PENNSYLVANIA POWER & LIGHT COMPANY
SUSQUEHANNA STEAM ELECTRIC STATION
OFFSITE DOSE CALCULATION MANUAL

SUMMARY OF ODCM CHANGES

FIGURE 1
LIQUID RADWASTE SYSTEM FLOW DIAGRAM

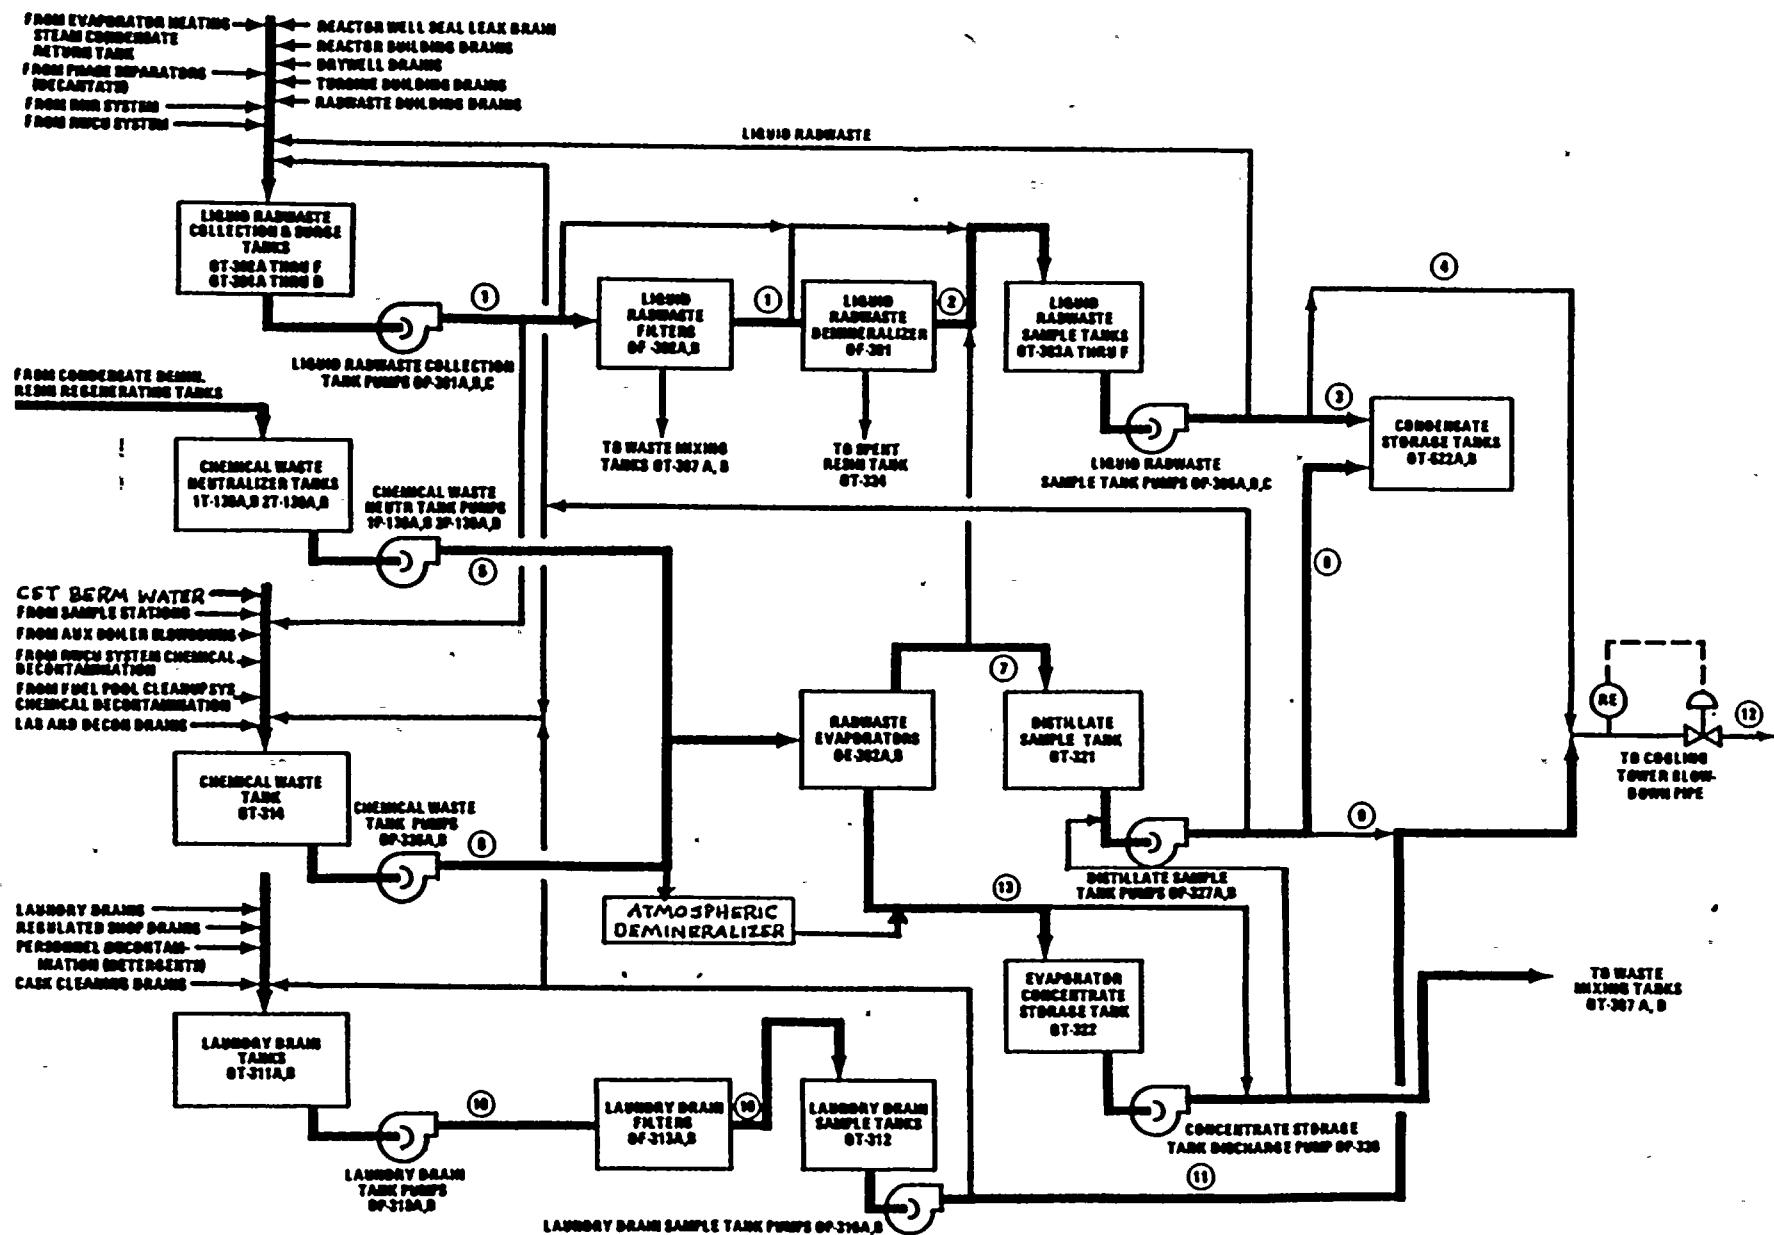
1. Section 10.6 "Definition of 'Appropriate Treatment' for Liquid Wastes" has been revised to provide for the use of the atmospheric demineralizer, prior to the startup and use of this system. The atmospheric demineralizer is considered appropriate treatment for the liquid radwaste chemical processing subsystem, specifically intended for organically-contaminated or other high-conductivity liquid waste. For batches containing no identified gamma activity above T. S. Table 4.11.1.1-1 LL0 level release without treatment is considered appropriate.
2. Figure 1, "Liquid Radwaste System Flow Diagram," has been changed to include the atmospheric demineralizer system. CST berm water has been added as an influent source to the chemical waste system.
